COMMUNITY DEVELOPMENT DEPARTMENT

HEARING DATE: December 8, 2020

SUBJECT: FP-2020-0011
Hensley Station No. 2

LOCATION: 462 N. Black Cat Rd., in the SW ¼ of
Section 10, Township 3N., Range 1W.

B. Final Plat (dated: 10/15/20)

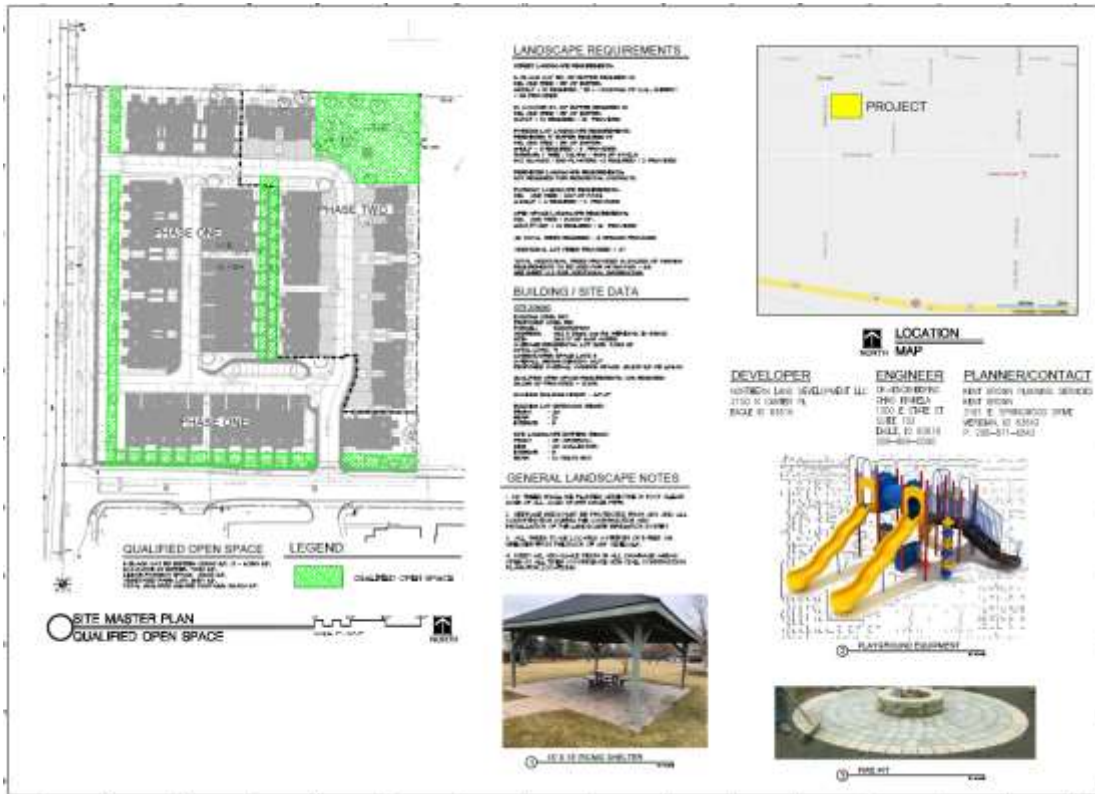
3. Prior to submittal for the City Engineer's signature, have the Certificate of Owners and the accompanying acknowledgement signed and notarized.
4. The final plat prepared by Land Solutions stamped by Clinton W. Hansen, dated: 10/15/2020, included in Section V.B shall be revised as follows:

- a. Include the recorded instrument number of the existing City of Meridian water and sewer easement on the face of the plat; remove reference to cross-access easement.

- b. Note #6: "~~Lots 52 and 57, Block 1 are~~ is a common lots to be owned and maintained by the Hensley Station Homeowner's Association or its assigns. Said ~~lots are~~ is covered by blanket easements for public utilities and Hensley Station Homeowner's Association pressure irrigation." *The area shown as Lot 52 is an easement on buildable lots and is not a common lot.*

- c. Note #8: Include the recorded instrument number of the Development Agreement (#2020-029370).
 - d. Note #9: Include the recorded instrument number of the ACHD License Agreement.

- e. Note #10: Include the recorded instrument number of the CC&R's.
 - f. Legend: "City of Meridian sewer and water, public utility and ~~cross-access~~ perpetual ingress-egress easement."

- g. Depict zero (0) lot lines where buildings will span across lot lines.

A copy of the revised plat shall be submitted with the final plat for City Engineer signature.
5. The landscape plan prepared by South, Beck & Baird, dated 04/20/2020, included in Section V.C, is approved as submitted.

C. Landscape Plan (dated: 04/20/2020)

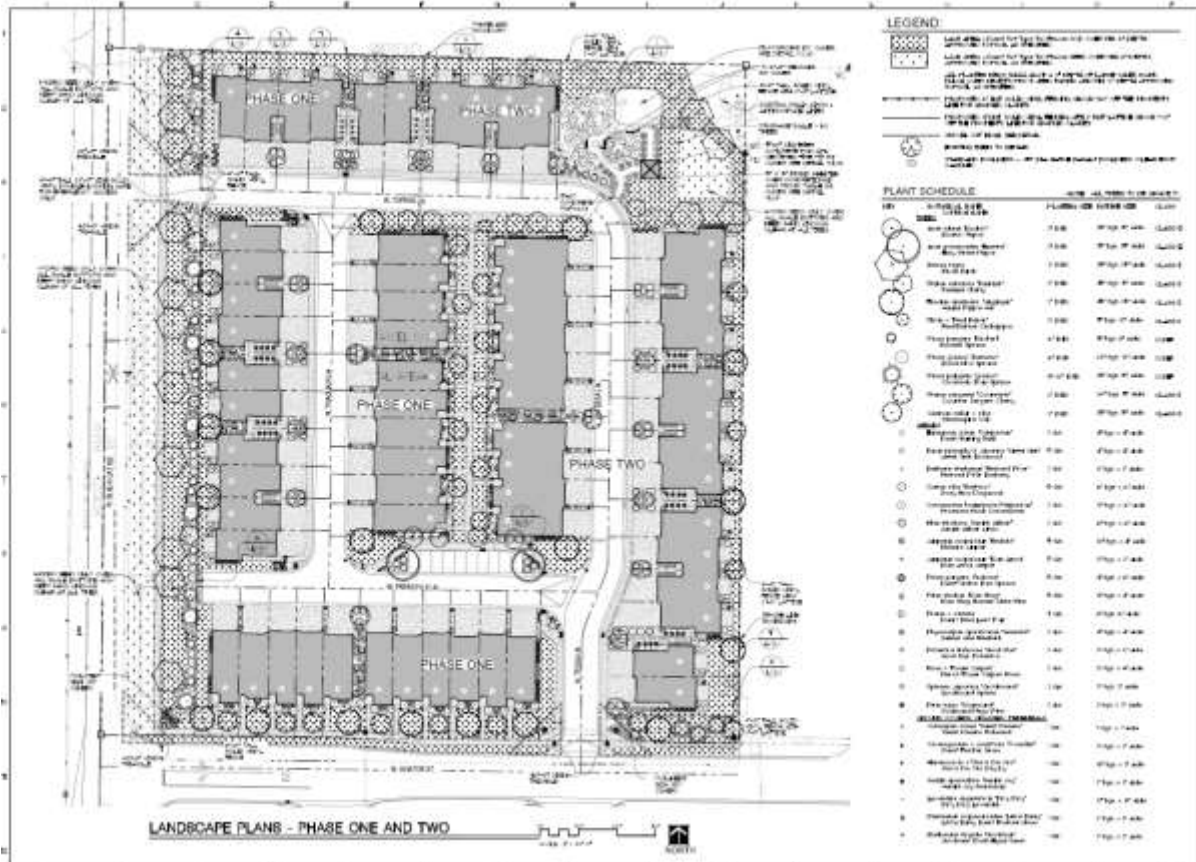
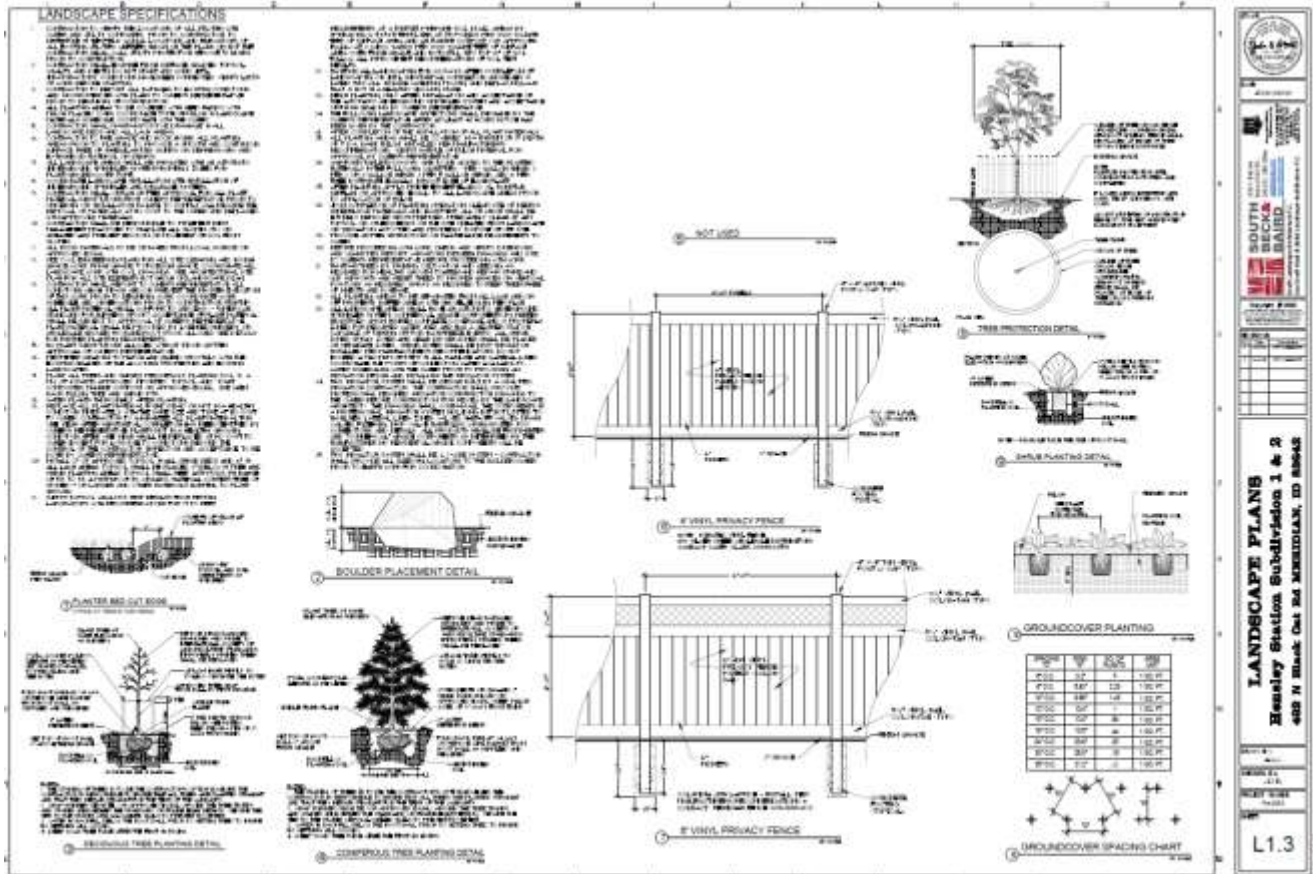
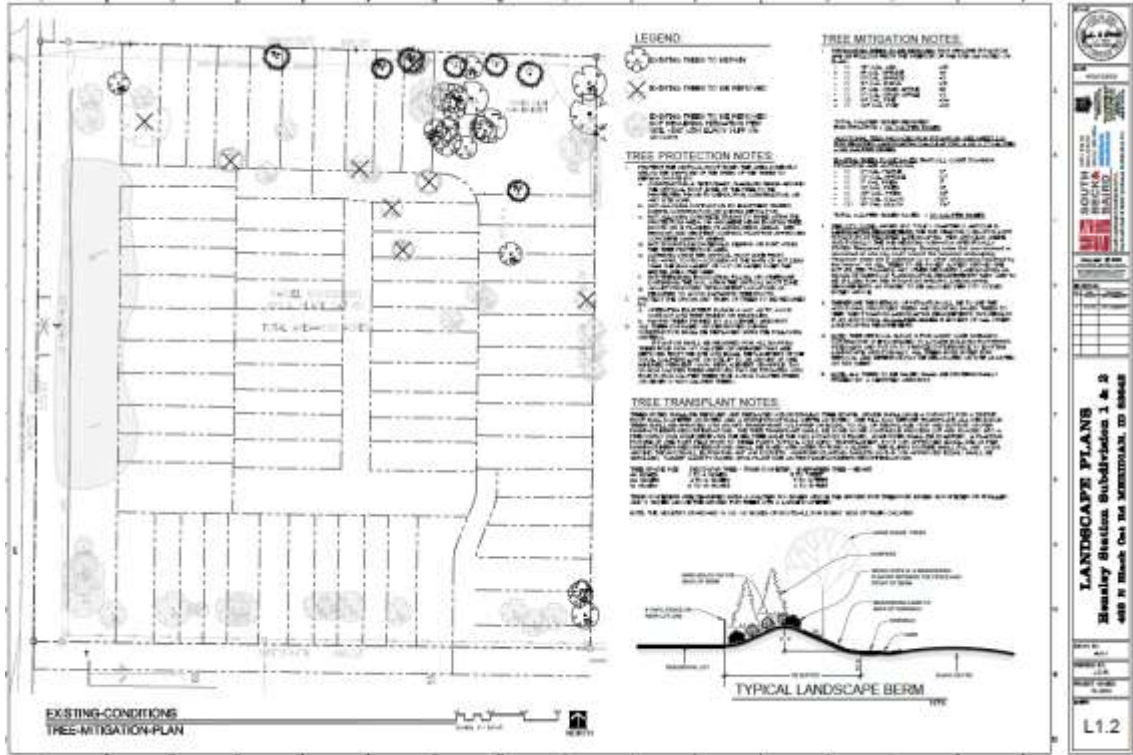
Note: Preliminary plat condition #A.3b required a total of 223 additional caliper inches of trees to be provided on the site for mitigation based on the original inspection by the City Arborist of existing trees on the site anticipated to be removed with development. Since that time, it's been determined that more trees than originally anticipated are able to be retained reducing the calculation to 136 caliper inches required for mitigation – the landscape plan depicts an additional (68) 2-inch caliper trees as mitigation in accord with UDC standards (see letter from Landscape Architect in Section V.C).

This email answers the questions regarding tree preservation and mitigation requirements on the referenced project. The condition of approval on the final plat application spoke to a total of 223 caliper inches being removed. During the course of preparing plans for final plat and construction, we have revised the landscape drawings. Per our current plan set, dated 4-20-2020, we indicate that we reduced the number of existing trees being removed. This new total requires 136 caliper inches to be mitigated for. The landscape drawing L1.0 shows required landscape calculations. These calculations for all required landscape buffers, parking lots, pathways and open space show an extra forty-one (41) 2" caliper trees to be planted. An additional twenty-seven (27) 2" caliper trees will be planted in residential yards above what is required. This totals 68 additional trees being planted on the project in excess of the minimum requirements. The proposed 68 trees equate to 136 caliper inches which equals the 136 caliper inches required to be mitigated.

We are saving an additional 321 caliper inches of existing trees. These are not counted toward any required landscape requirements, they are simply for the City's information of how many trees are in fact being saved. I hope that this message answers the City's questions regarding satisfying the tree preservation/ mitigation requirements as conditioned in the preliminary plat approval. Please let me know if you have any questions or need additional information.
